WAT PRATHAT DOI SUTHEP
BUDDHIST TEMPLE OF NEW MEXICO
EPC SITE PLAN MAJOR AMENDMENT
DFT SIGN OFF

EPC MAJOR AMENDMENT DFT SIGN OFF DOCUMENT

Project # PR-2022-007851
SI-2022-02075 - Site Plan- Major Amendment

RE: PR-2022-007851, SI-2022-02075-Buddhist Temple, Site Plan – EPC Major Amendment

2 SOUTH ELEVATION
SCALE: 1/2" = 1'-0"

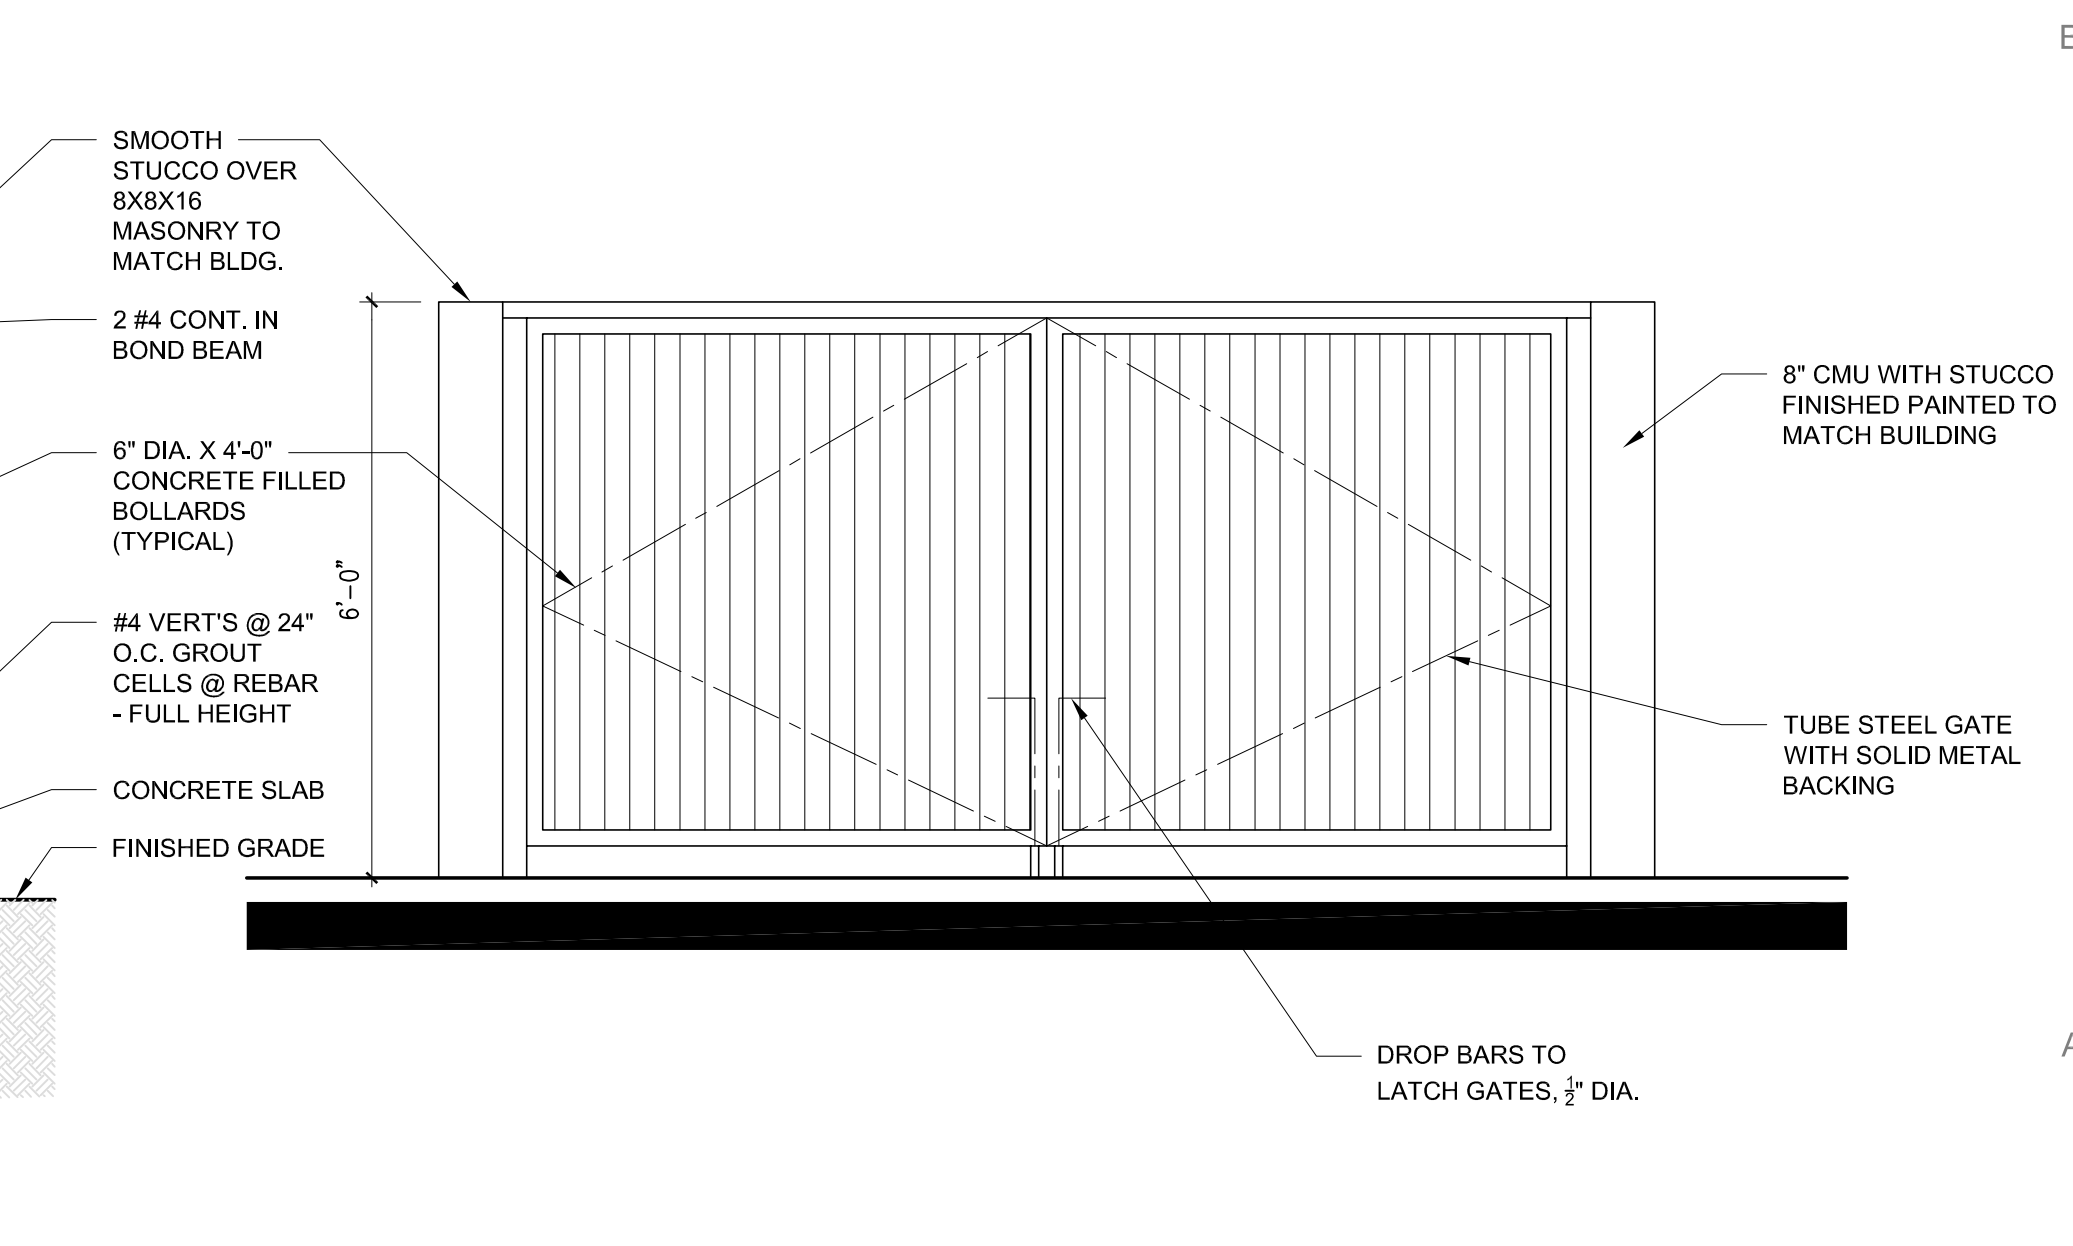
6. Elevations shall specify building materials and colors.
7. CONDITIONS FROM THE SOLID WASTE MANAGEMENT DEPARTMENT
 - A. A site plan approved for access signed by the Solid Waste Department will be required.

The trash enclosure design on sheet A1.3 Plan & Details reflect the SWMD dimensions and construction materials requirements of the "enclosure specifications" document. This enclosure does not require an exterior sanitary sewer drain, this facility is not a "Restaurant, Food Services or Food Distributors" function.
